NOTICE OF DECISION

ADMINISTRATIVE SITE DEVELOPMENT PERMIT GILMAN POINT

APPLICATION NO: ASDP15-00002

Project name: Gilman Point

ARCHITECTURAL SITE PLAN
A0.2

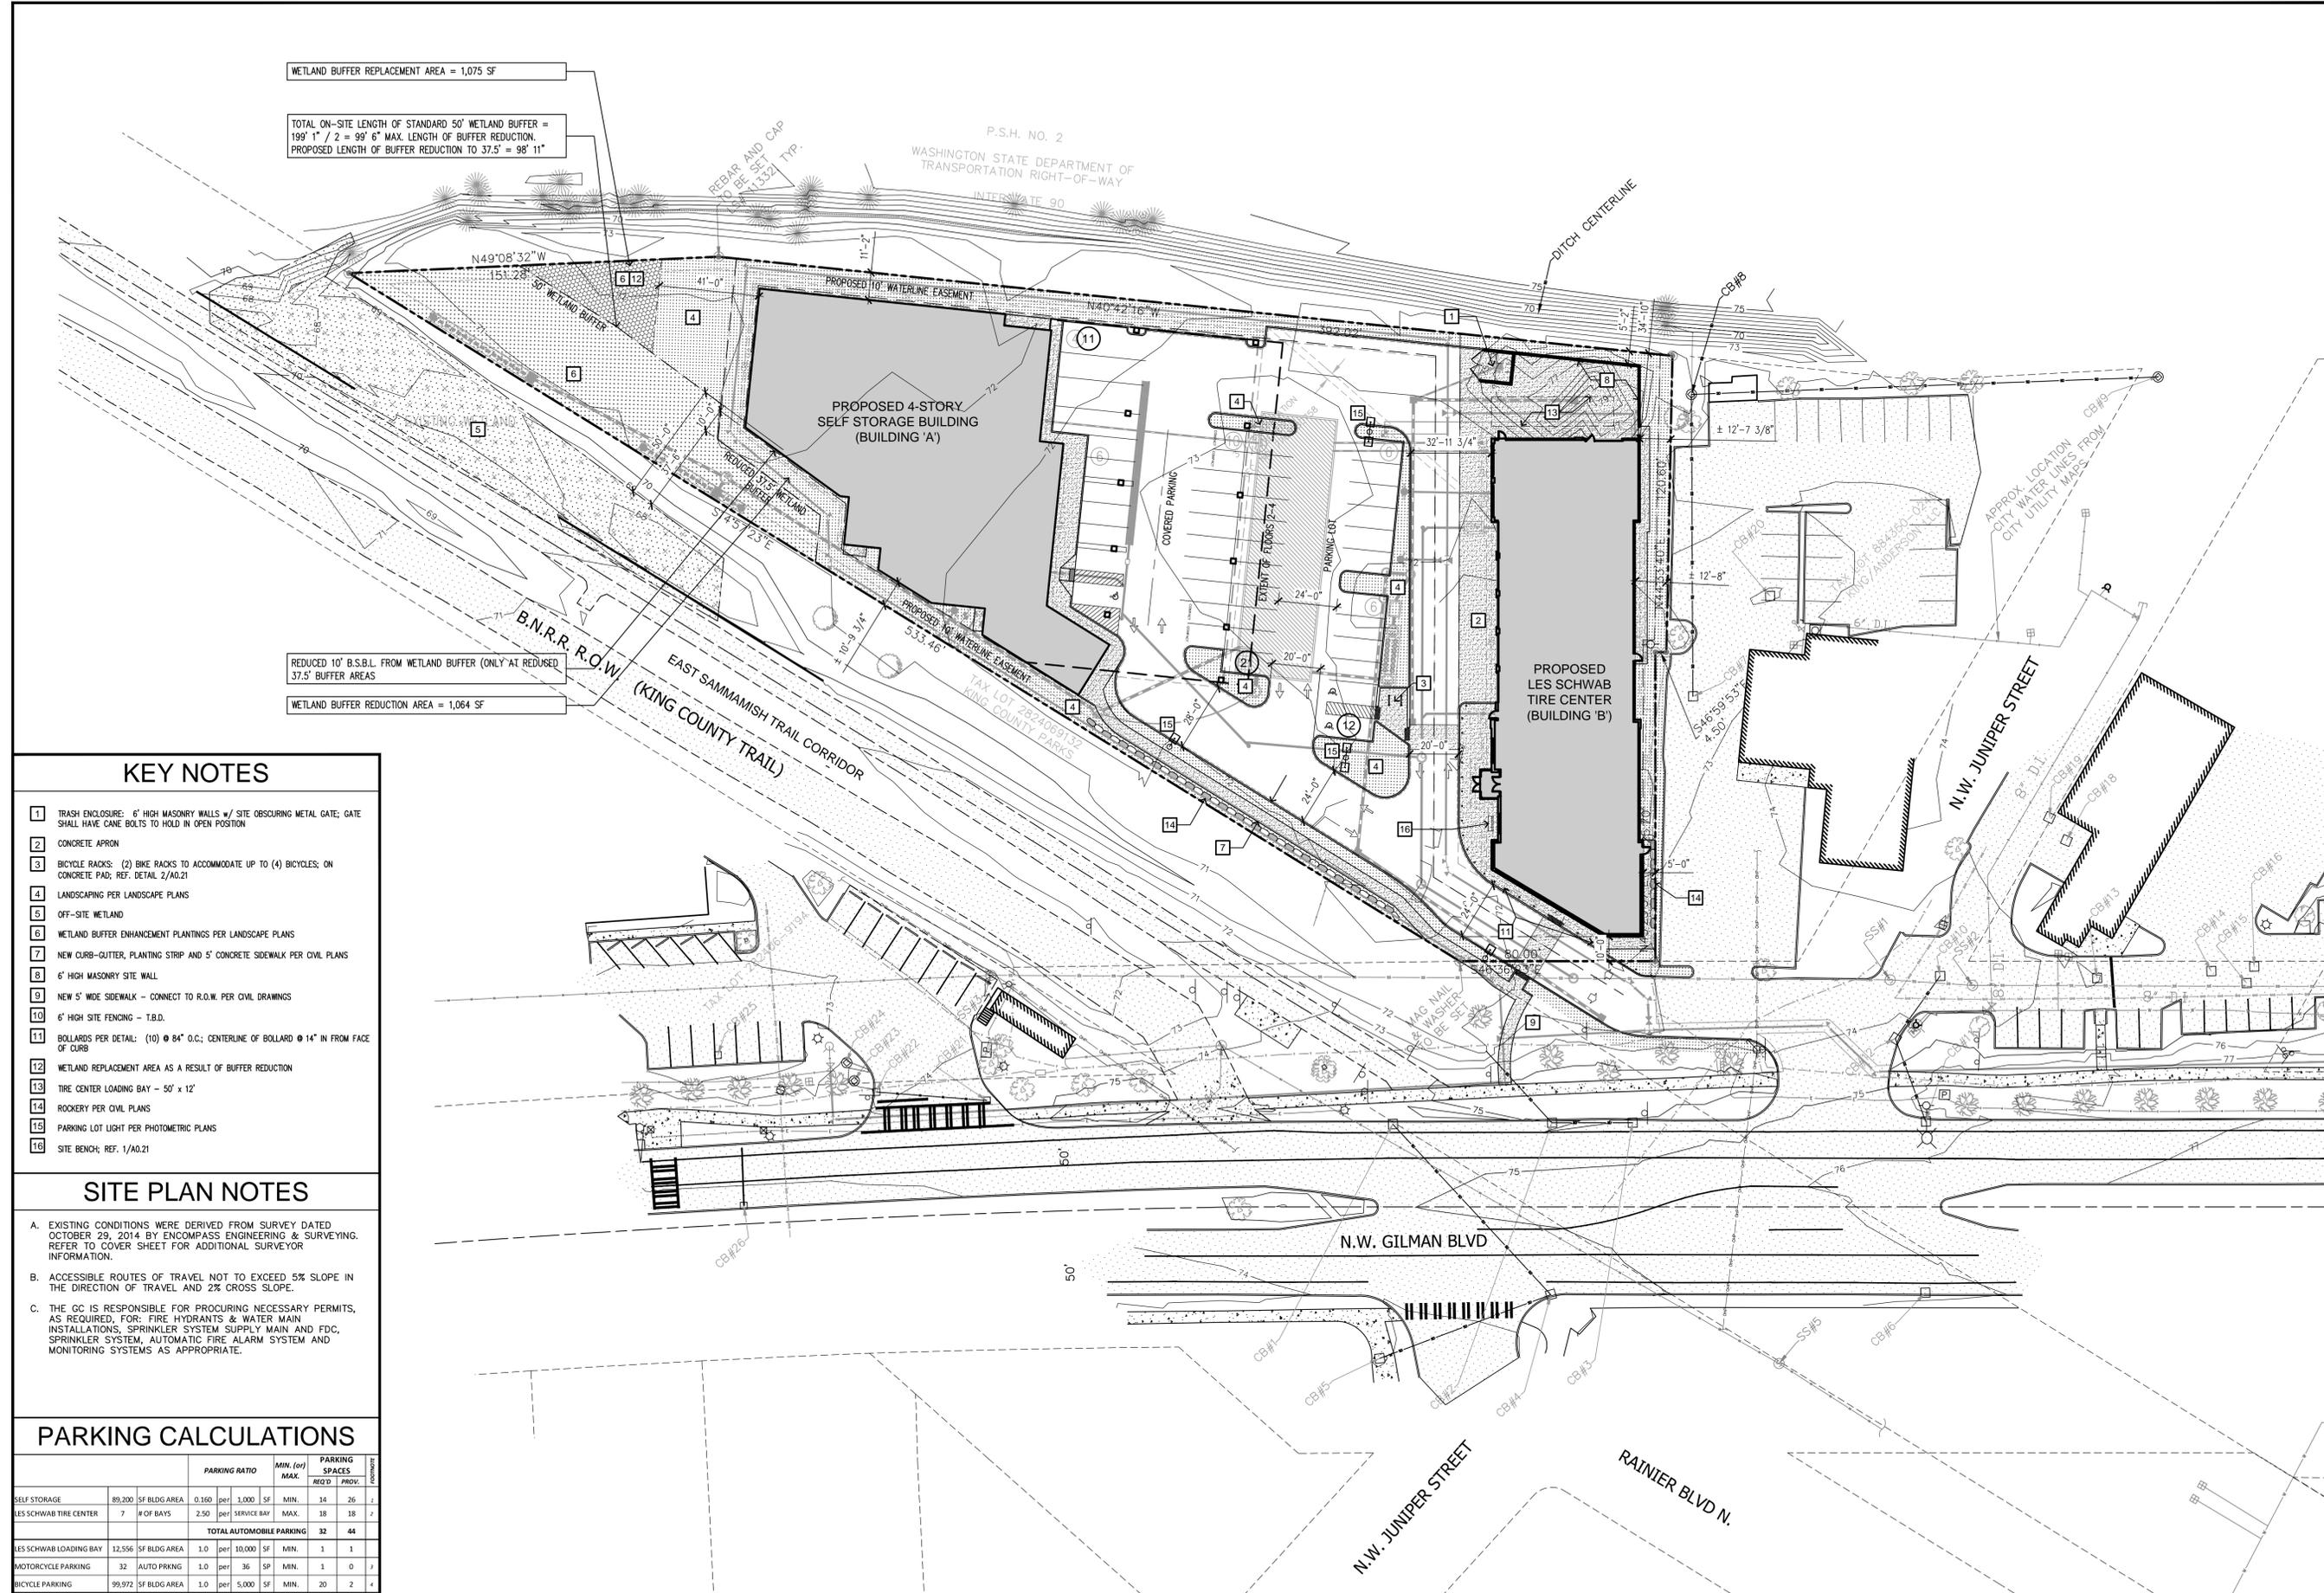
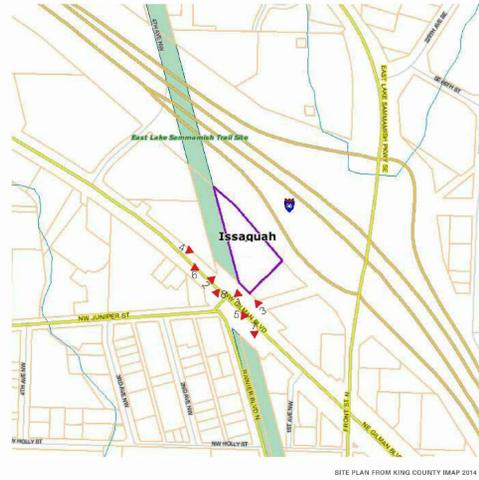
Condition 9: Parking stall dimensions shall be the minimum necessary per the requirements. For standard stalls, the maximum dimension shall be 9 x 18.5 feet. If compact stalls are used, they shall be 8 x 16 feet. Where feasible, use of the 2 foot overhang into planted areas is encouraged.

8.18.B.5	Surface Lot Materials				X	To be reviewed at site work permit.	
8.18.B.6	Marking		X		X	No Parking – Fire Lane striping is shown on Sheet C1.0 for use in several locations within the parking lot. Striping (paint) should not be used except at the discretion of the Fire Marshal. Signage shall be used to indicate No Parking – Fire Lane area.	Condition 11: “No Parking – Fire Lane” zones shall be indicated by the use of signs. Painted curbs shall not be used unless expressly directed by the Fire Marshal.

SITE AMENITIES, CONTEXT PHOTOS AND NARRATIVE
A0.21

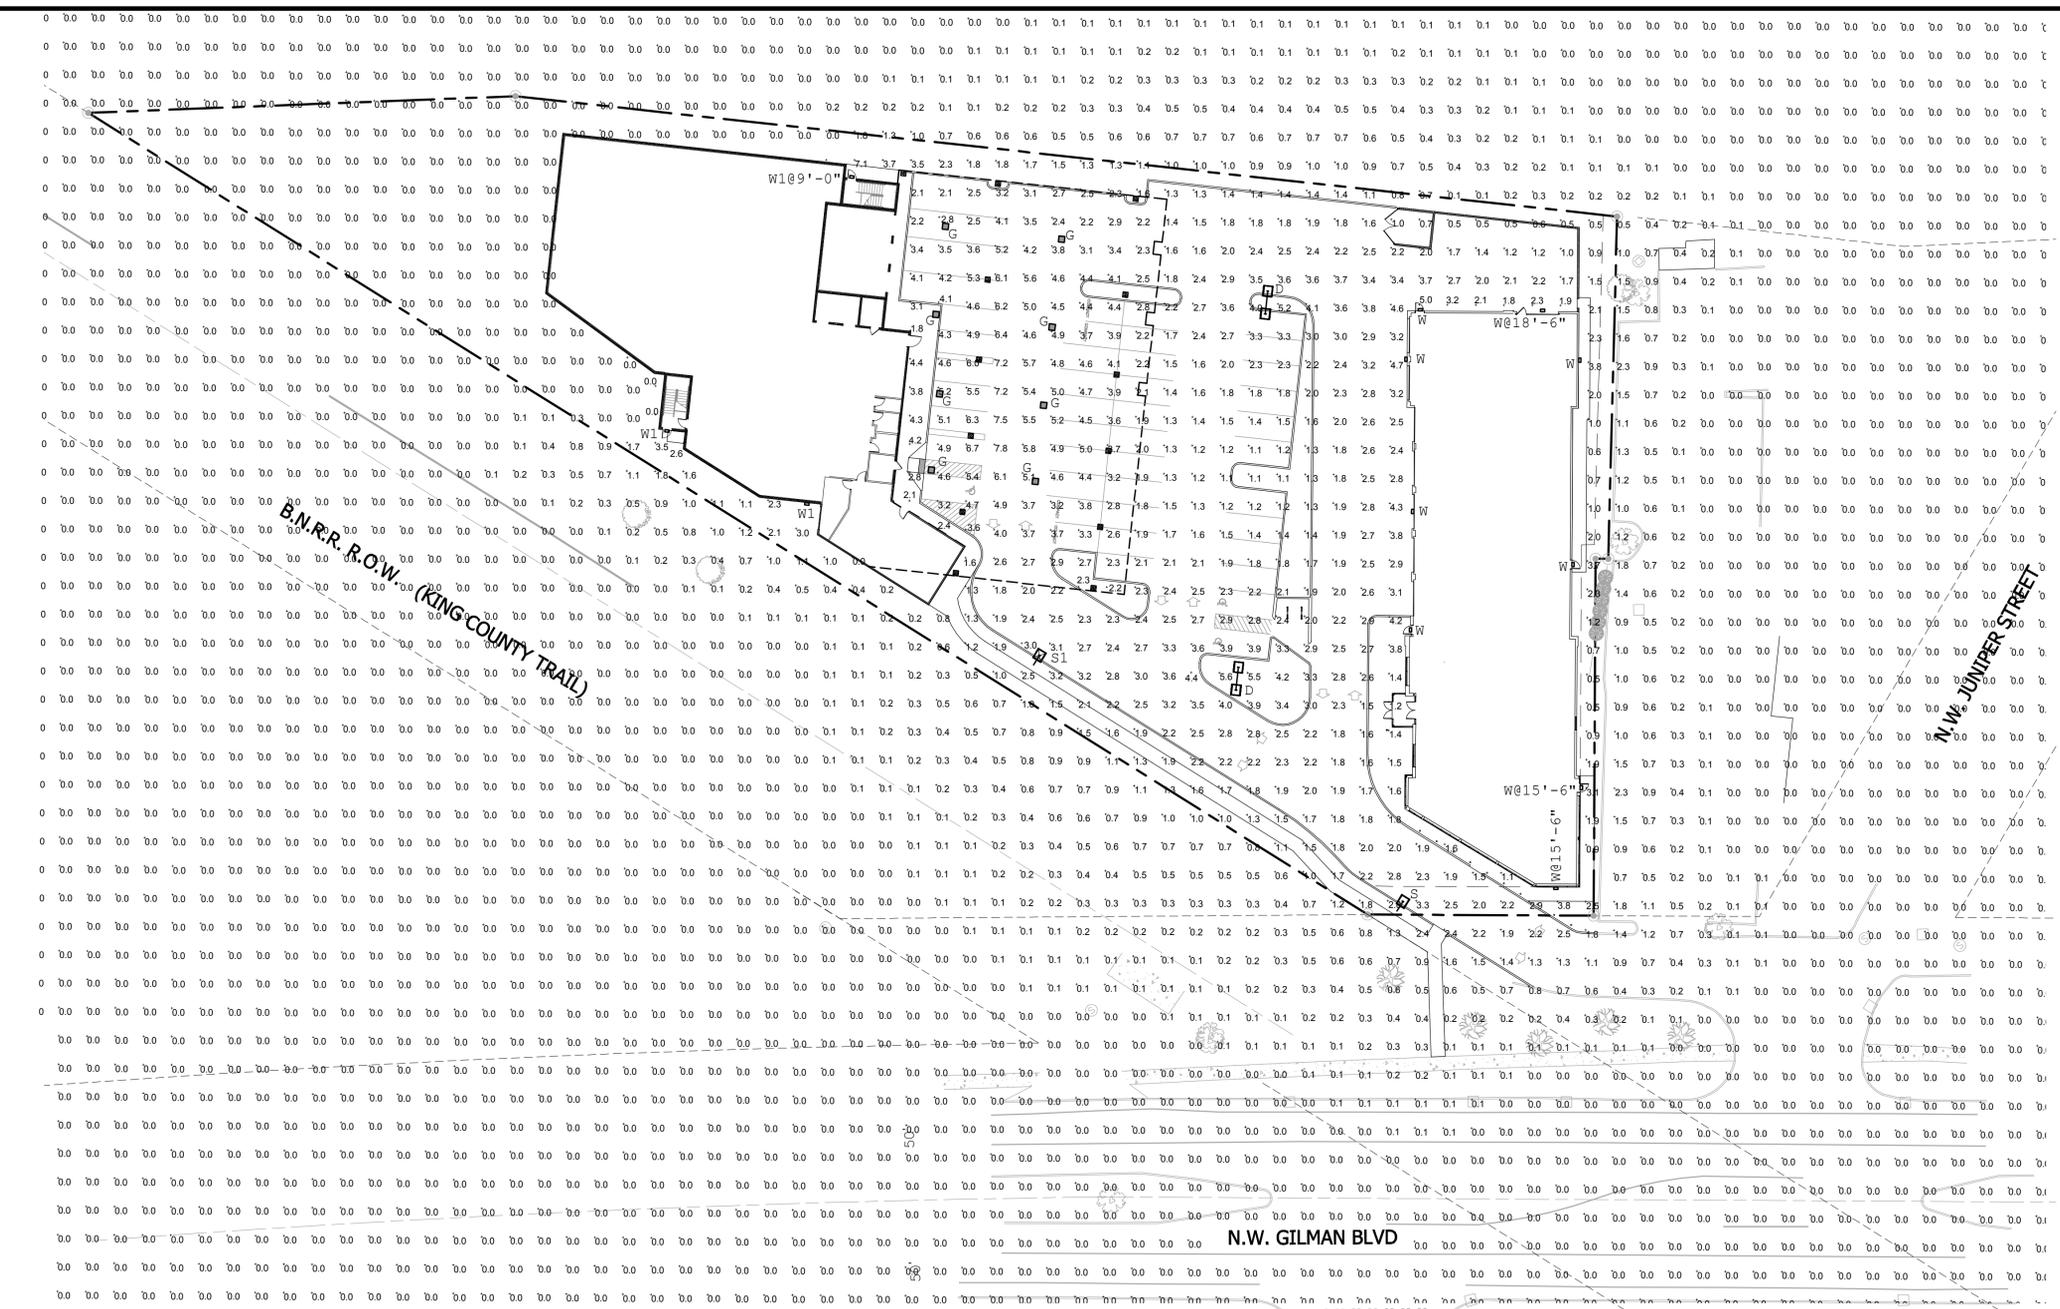
17.2	General					Photometric plans (Sheet A0.3) were provided with the application but have not been reviewed for compliance with any applicable codes. To be reviewed for compliance at construction permit phase	
17.2.A	Safety at night				X	To be reviewed with Construction permits.	
17.2.B	Intuitive				X		
17.2.C	Sustainable				X		
17.2.D	Contribute to the public realm				X		
17.2.E	Dark sky elements				X

17.2.G	Use as architectural elements				X		
17.2.H	Volume of Space				X		
17.2.I	Illumination levels				X		
17.3	BUG				X		
17.4 A-E	Design and Fixture Standards			X		A design detail for interior site lighting is provided on Sheet A0.3 that does not comply with the standards as it is too tall. The proposed light is 25 feet high which exceeds the allowed light pole height by 10 feet. The proposed light pole shall not be used.	Condition 26: Light poles shall not exceed 15 feet in height.

CIVIL CIRCULATION PLAN
C-2.0

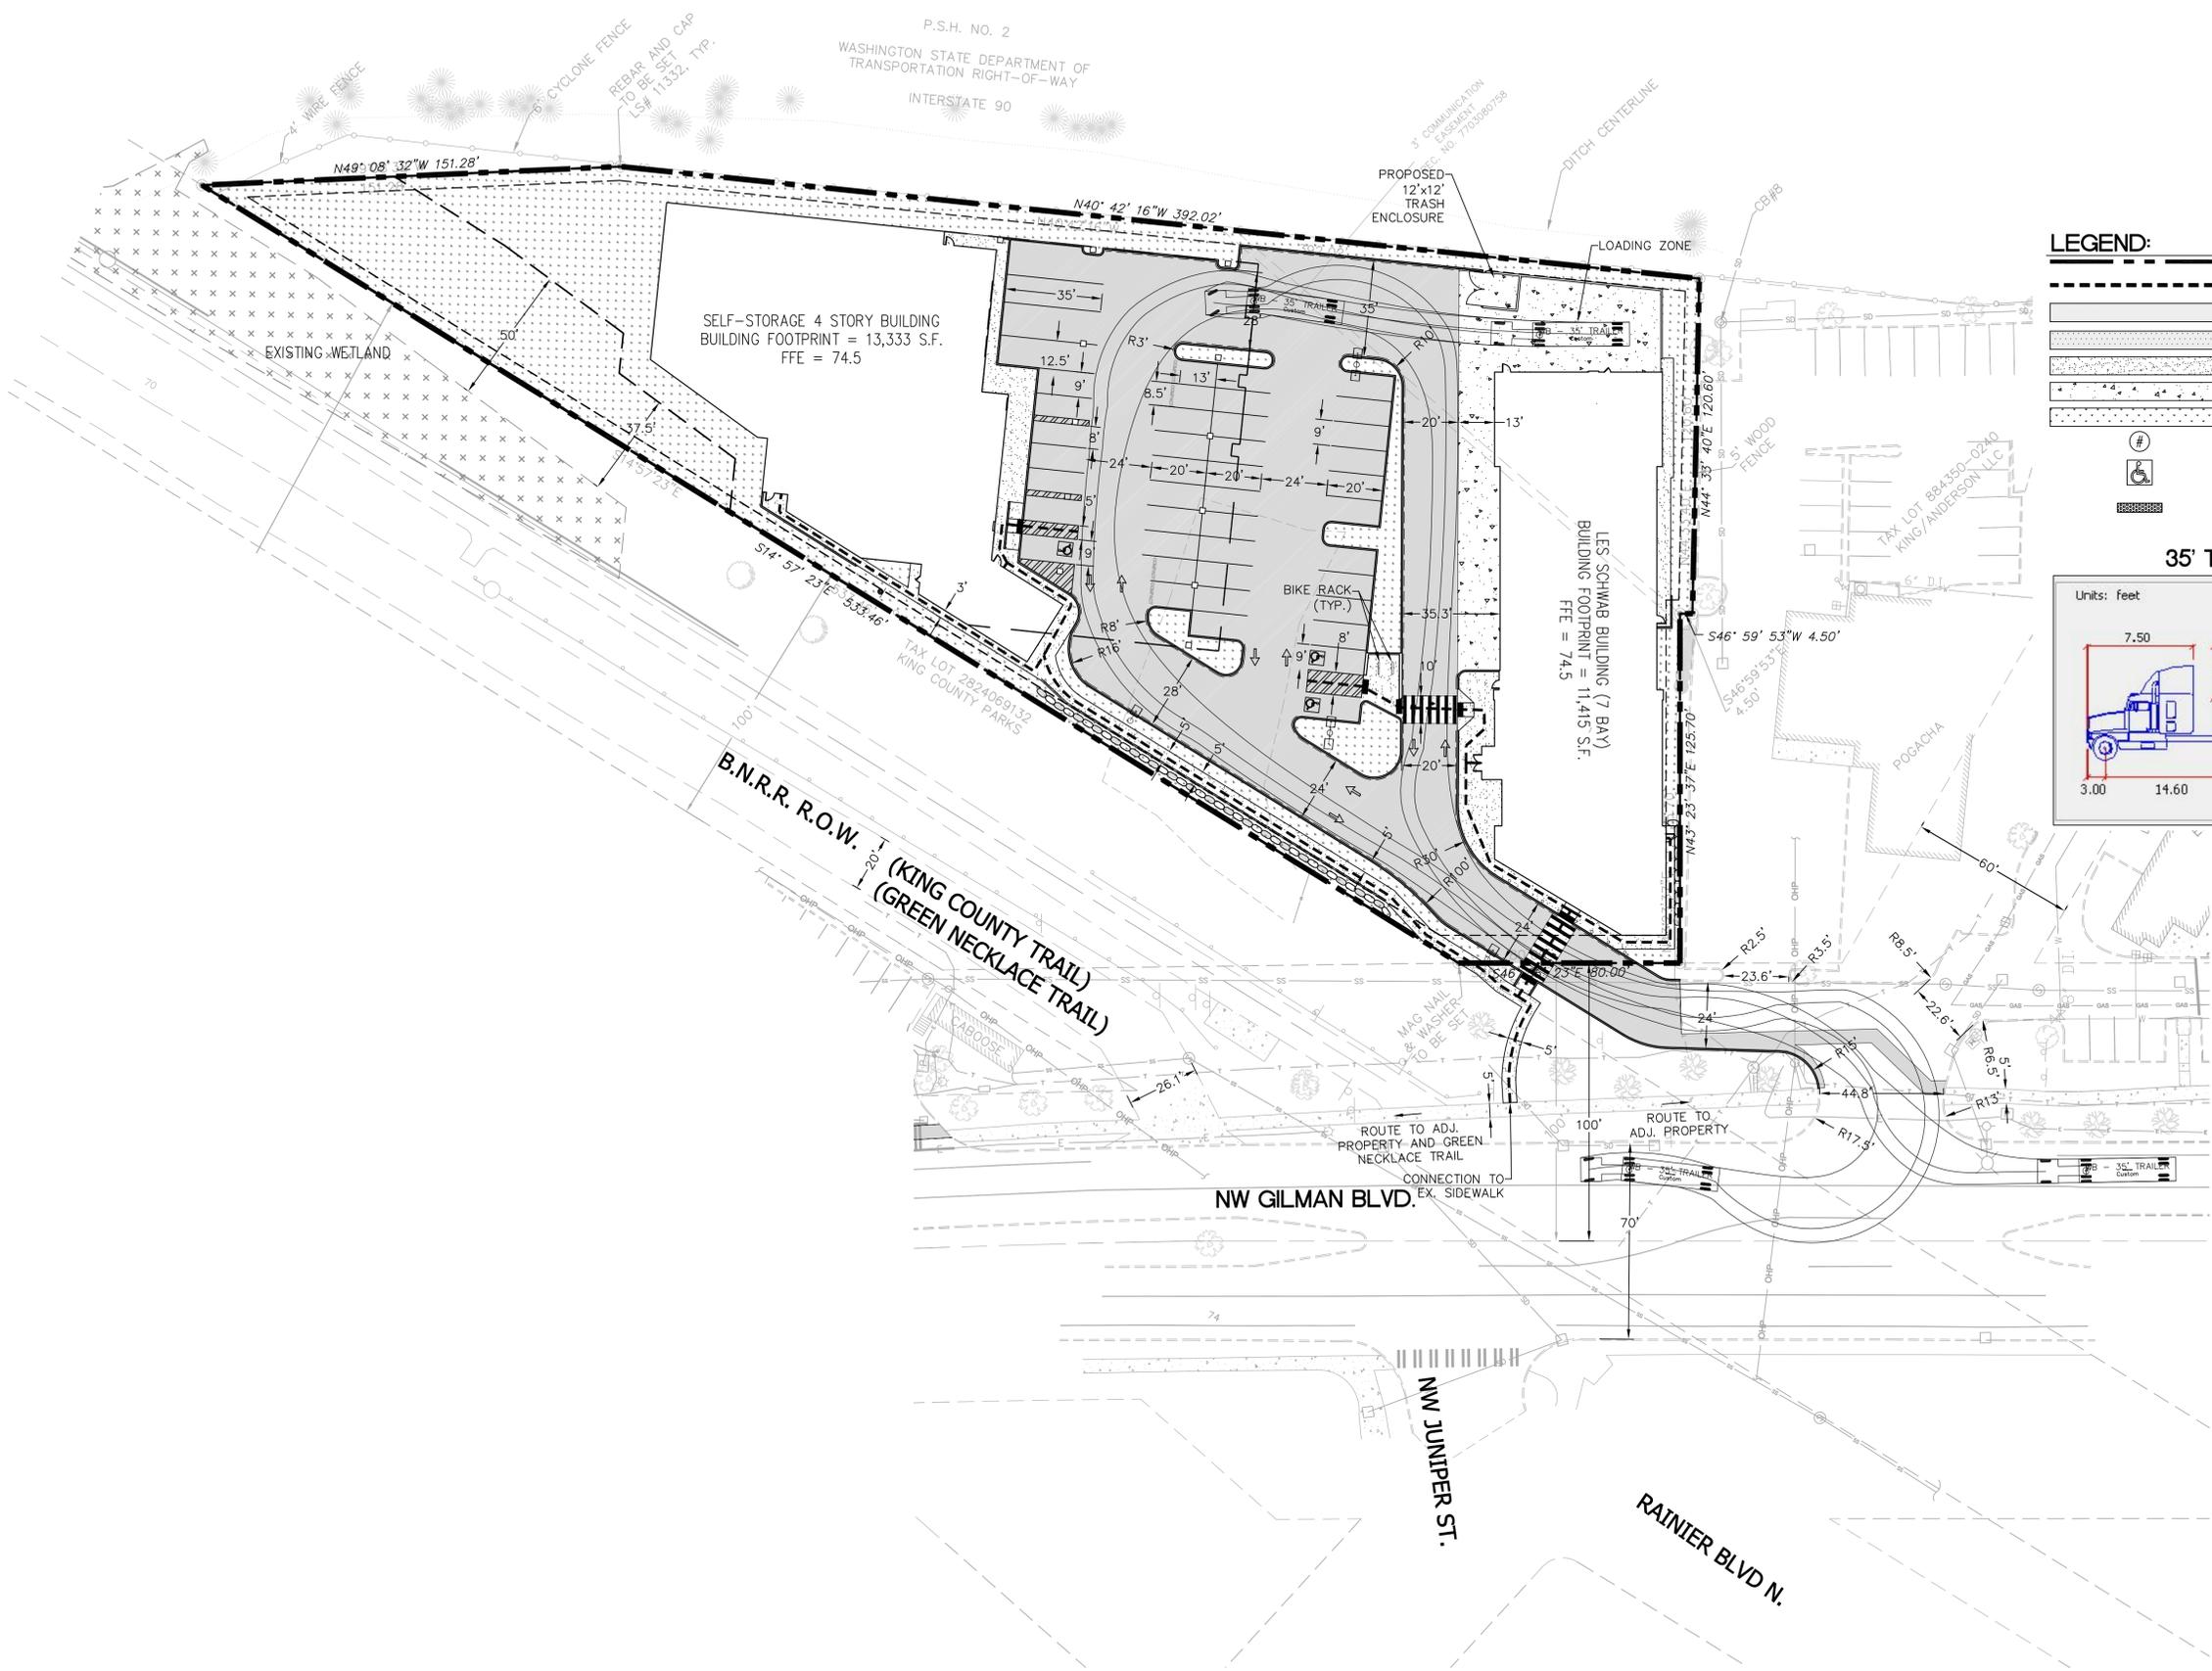
12.6.A	Planting areas		X		X	Complies.	
12.6.B	Planter width and design per Sec. 6.4		X		X	A 5-foot tree planter strip is provided for the internal street – see Sheet C2.0. This will be verified with the Site Work permit.
